PPPL ENGINEERING CHANGE NOTICE (ECN) ECN # 5185

ECN TITLE: Flange Hole Counterbore Clearance Envelope and Type-B Post Mod

CC/WP/Job: 9450-1*-1411** **AREA OR PROJECT: NCSX**

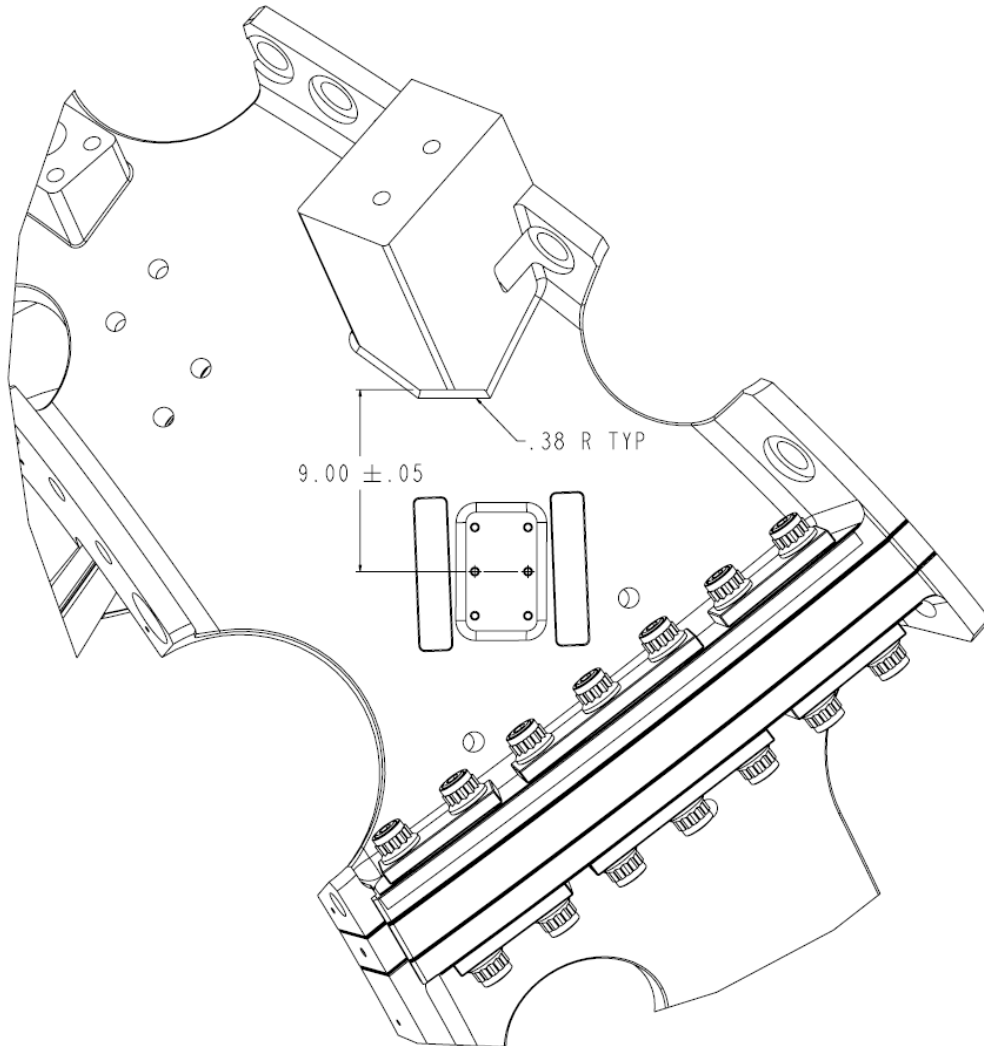
SE141-114, -115, -116, Sht-4, 5 -The clearance requirements for all flange back spot faces and for all the remaining winding forms (MCWFs C-6, B-3 through B-6, and A-4 through A6) shall be a 3" diameter cylinder 3" high from the spot face surface. The blend-in radius at the upper extent of this machined area shall be 1/4".

The CAD model of the counterbore envelope, 3-in dia x 3-in length with a spherical radius, is not large enough to provide adequate fastener clearance in heavy stocked areas of the casting.
